Appl. No. 09/964,204
Response dated June 19, 2003
Response to Office Action of December 19, 2002

REMARKS/ARGUMENTS

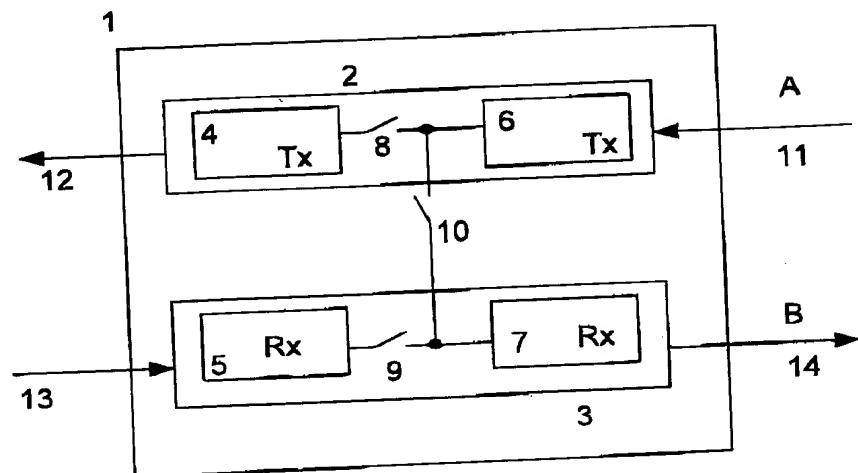
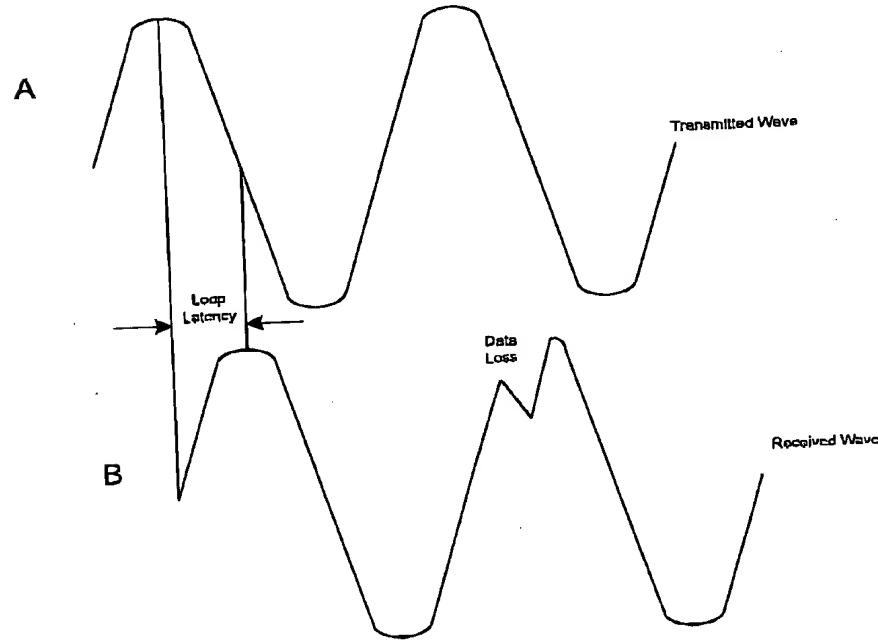
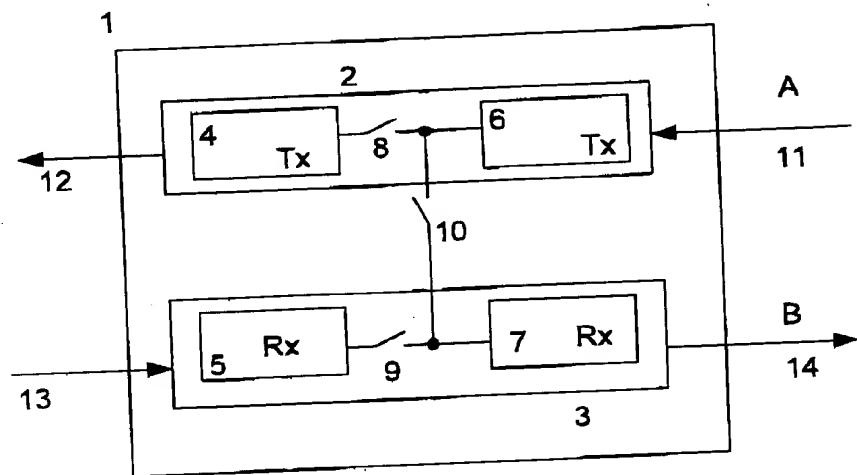
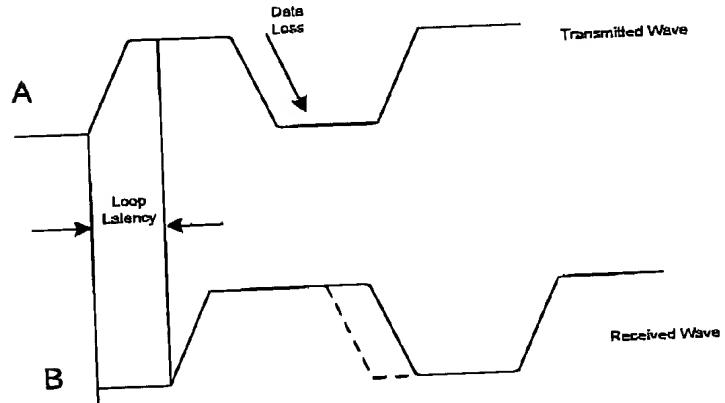
The drawings are objected to by the Examiner for failing to include the first and second circuit node recited in claim 1. Applicants have cancelled claim 1, rendering this basis of objection moot. The drawings are further objected under 37 CFR 1.84(p)(5) for failing to include reference sign 6 referred to in the specification. In response, Applicants have amended Figures 1a and 2a to include the reference sign 6. Amended Figures are included in the attached Replacement Sheets for Examiner's approval.
